**Bastrop County Precinct 2 Road and Bridge Facility Construction**

**RFB 25BCP04J**

**ADDENDUM #2**

Addendum #2 provides clarification and answers from questions submitted by contractors and has an updated drawing and specification package as some aspects of the project have changed. Bastrop County is extending the due date for submissions until June 4, 2025, at 2:00PM. The new deadline for questions concerning the scope of work is May 27, 2025, at 5:00PM. Below is a list of documents that are included in Addendum #2:

# 1 ARCHITECTURAL SITE PLAN

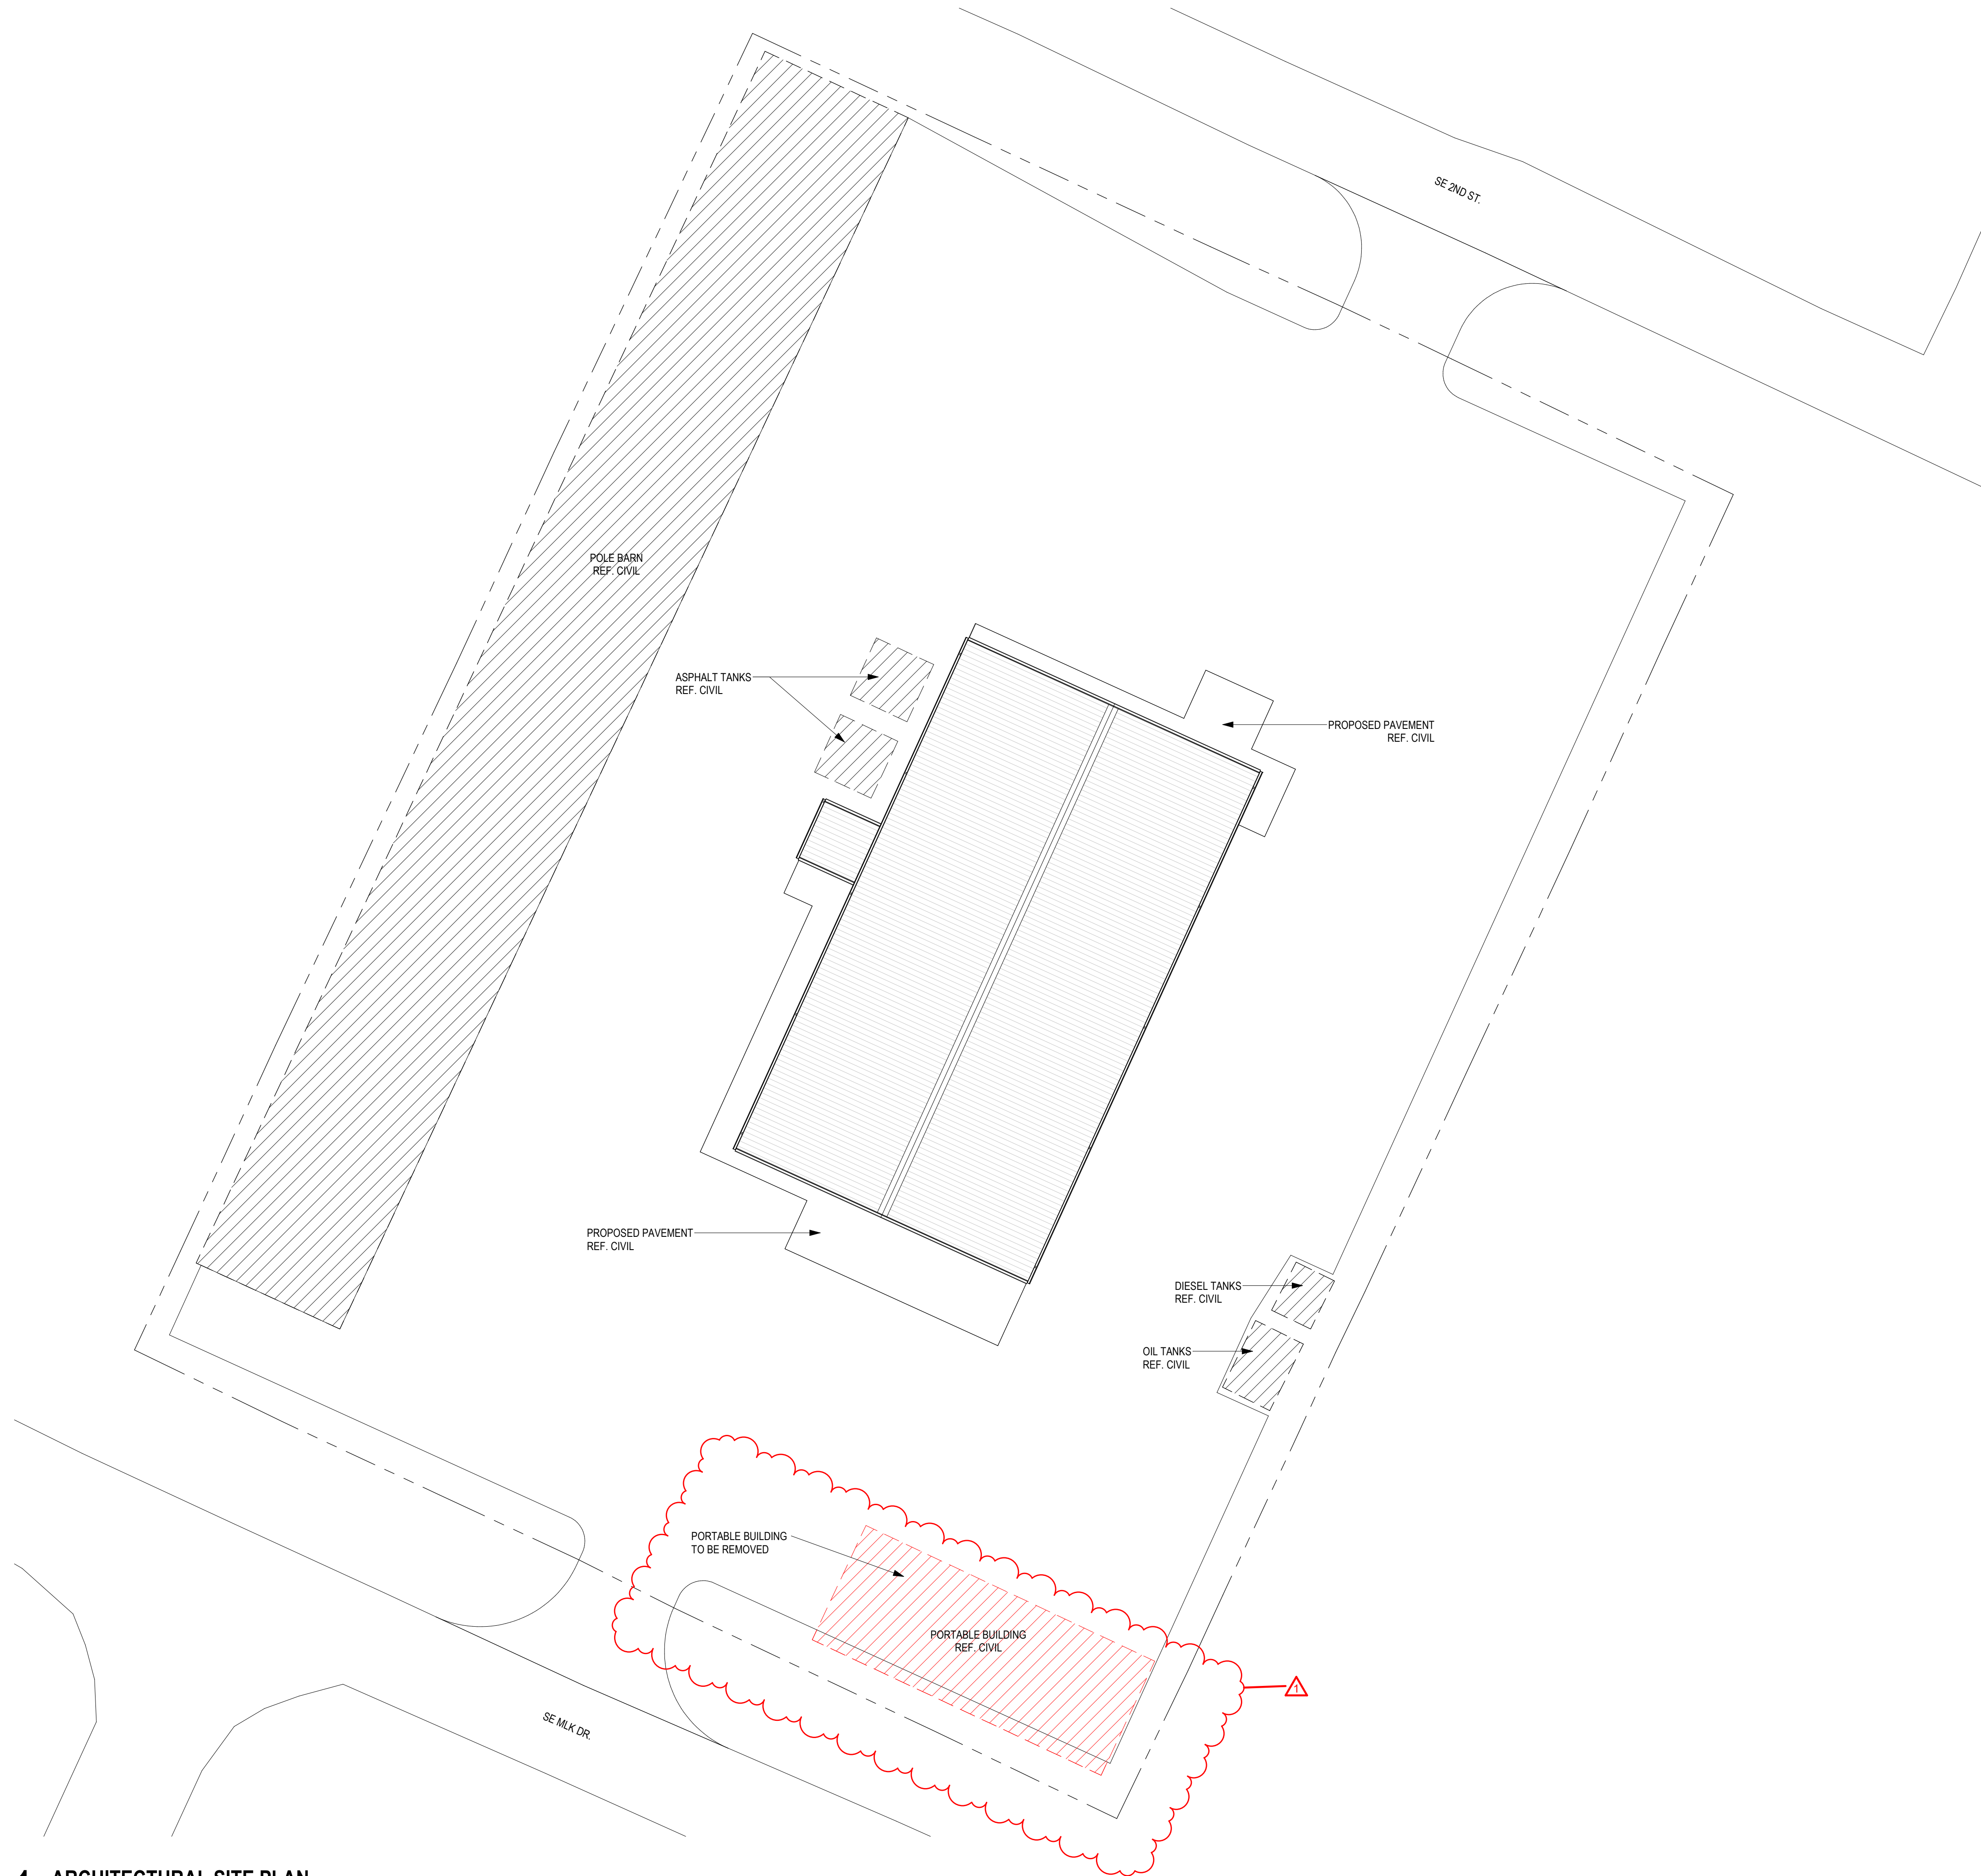
1. Revise site plan and call out all existing and proposed fences. Include fence height and building material.
  - a. Included proposed wood fences. **Ref. Civil Dwgs- 1**
2. Revise the architectural site plan and show the temporary building located in the SE corner of the property as 'to be removed'. **Ref. Arch Dwgs- A007**

CasaBella Architects Response: Refer to revised sheet 1/A007, Added revision Cloud to existing building to be demolished

# 1 REFLECTED CEILING PLAN

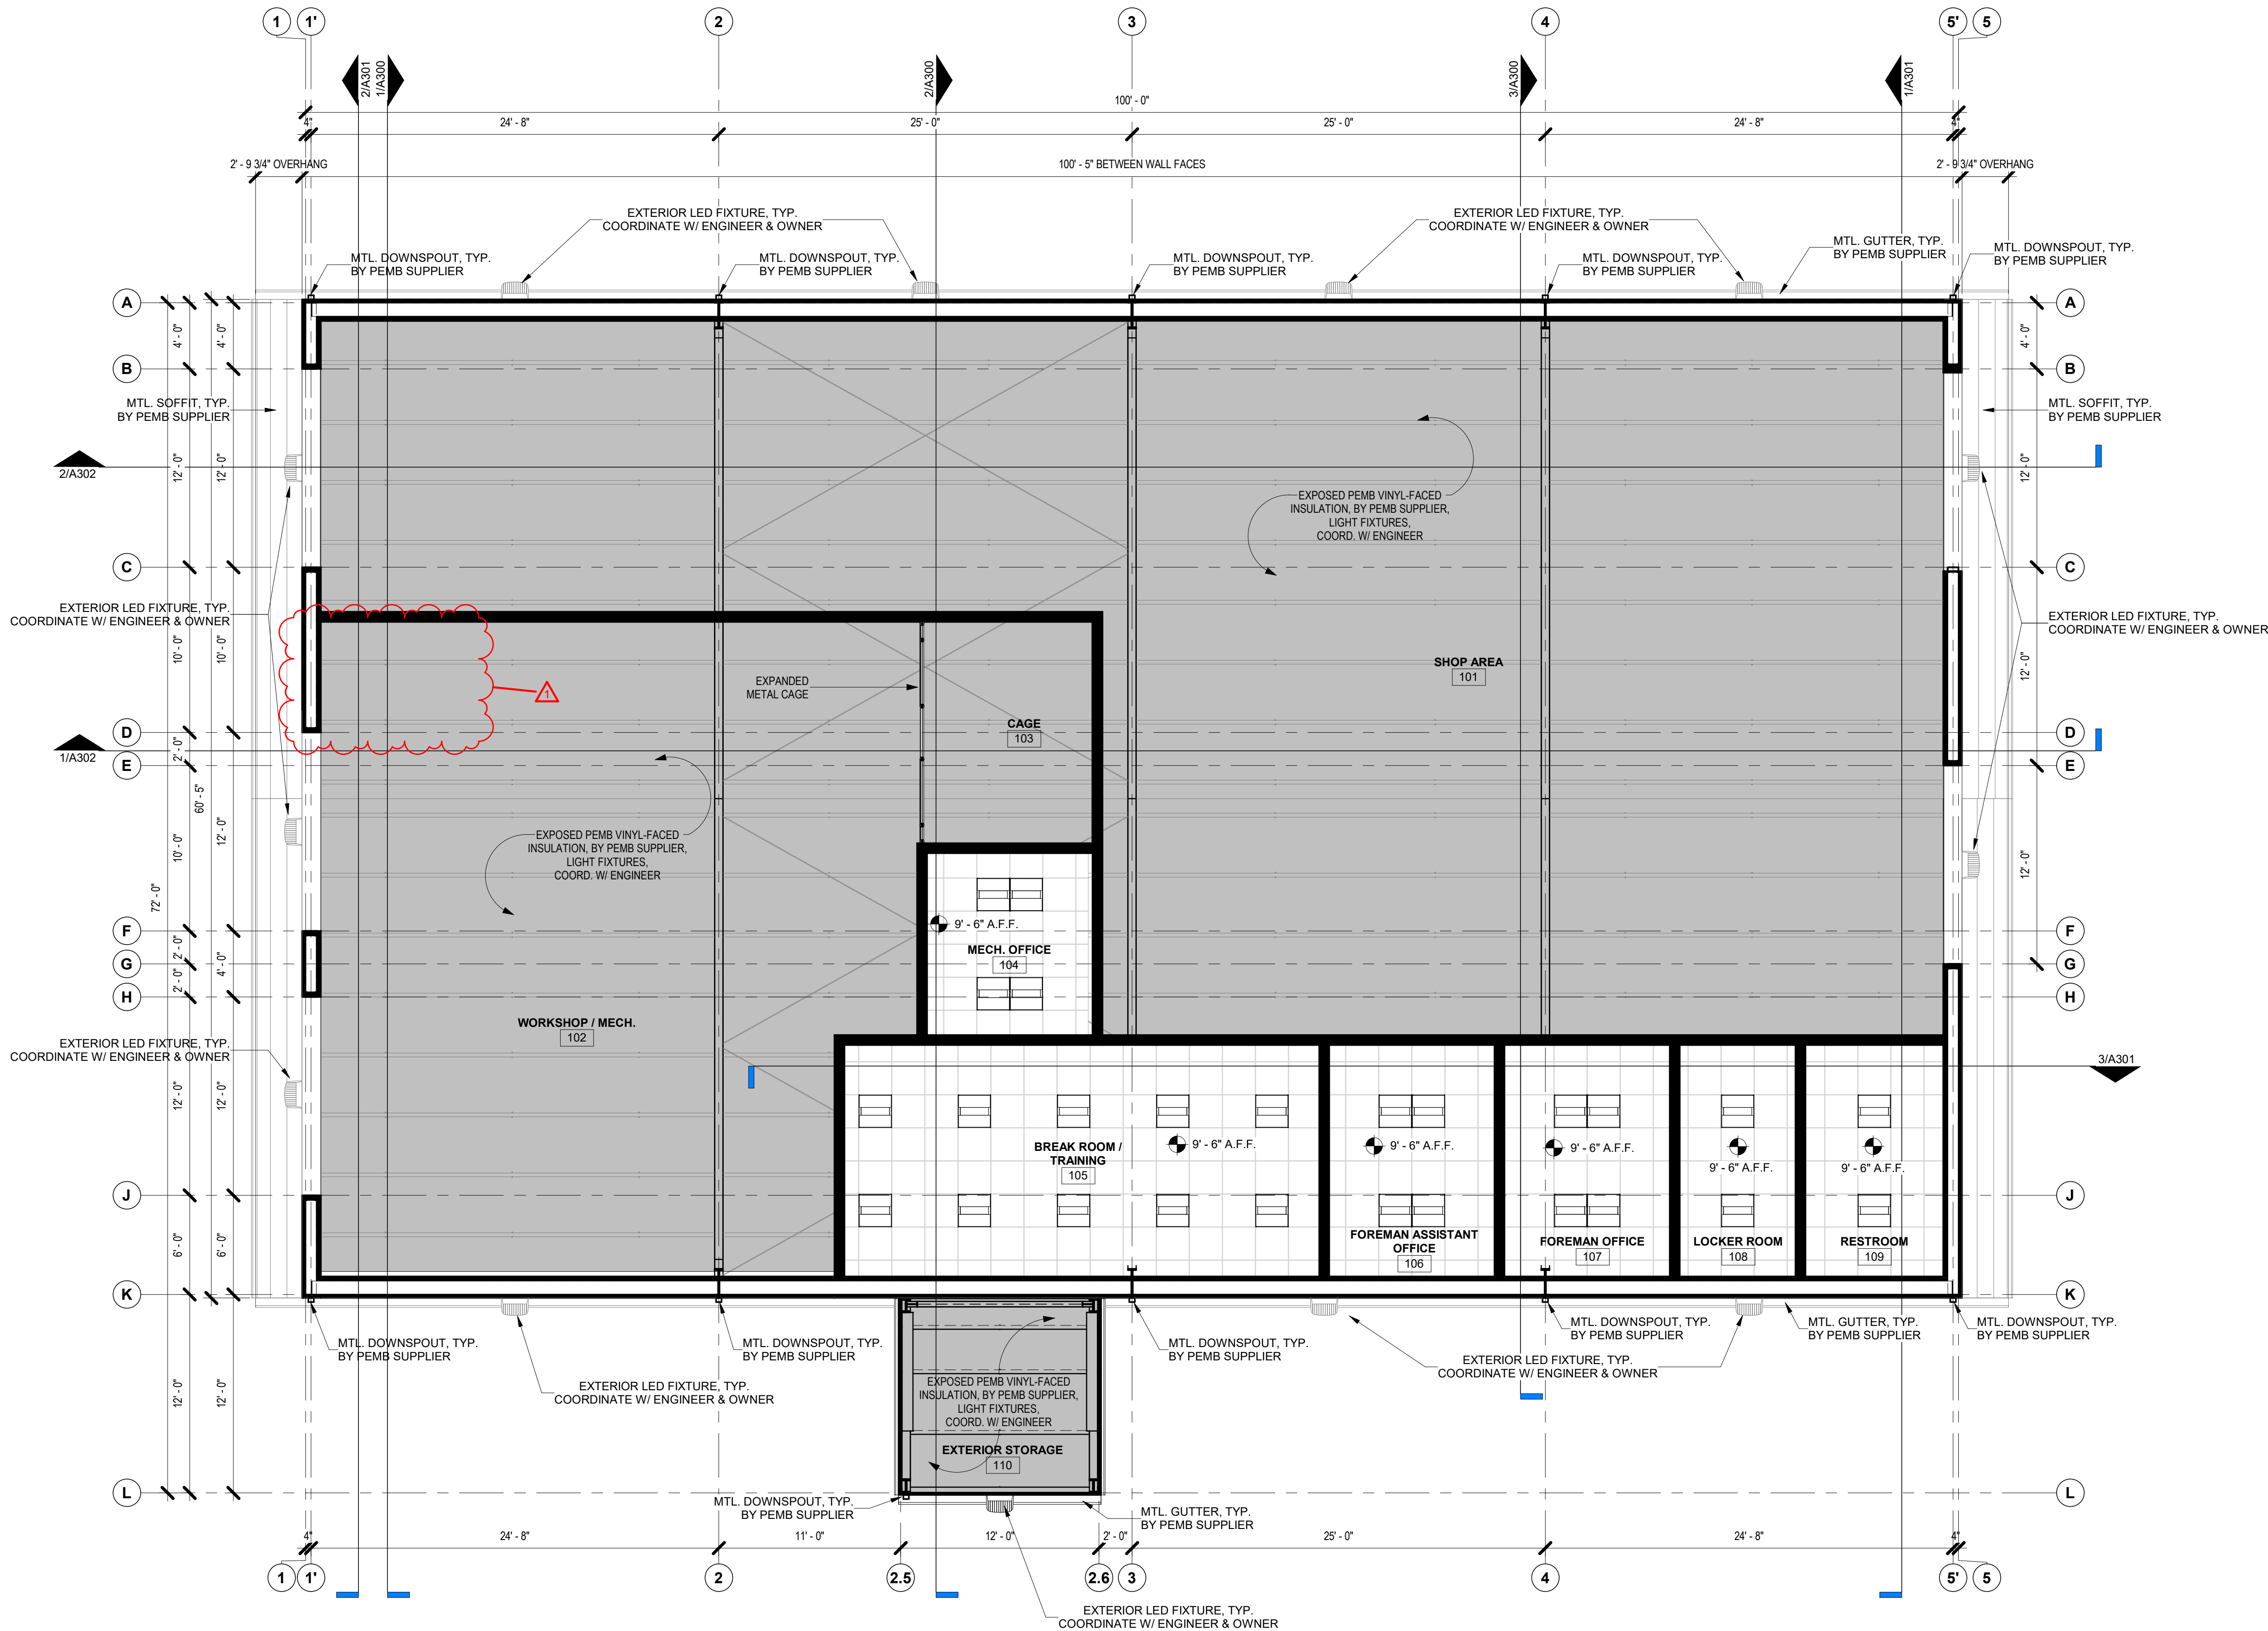
- Questions submitted by Frontera Construction via email – see attached email dated May 13, 2025:
  1. See sheet A103 for Reflected Ceiling Plan and Legend
  2. The building has been demolished and removed. The subgrade and base material have been placed and compacted to grade by Bastrop County.
  3. The County will remove the excavated material (grade beams and piers) – see Scope of Work. Contractor to excavate the grade beams and piers – See Scope of Work.
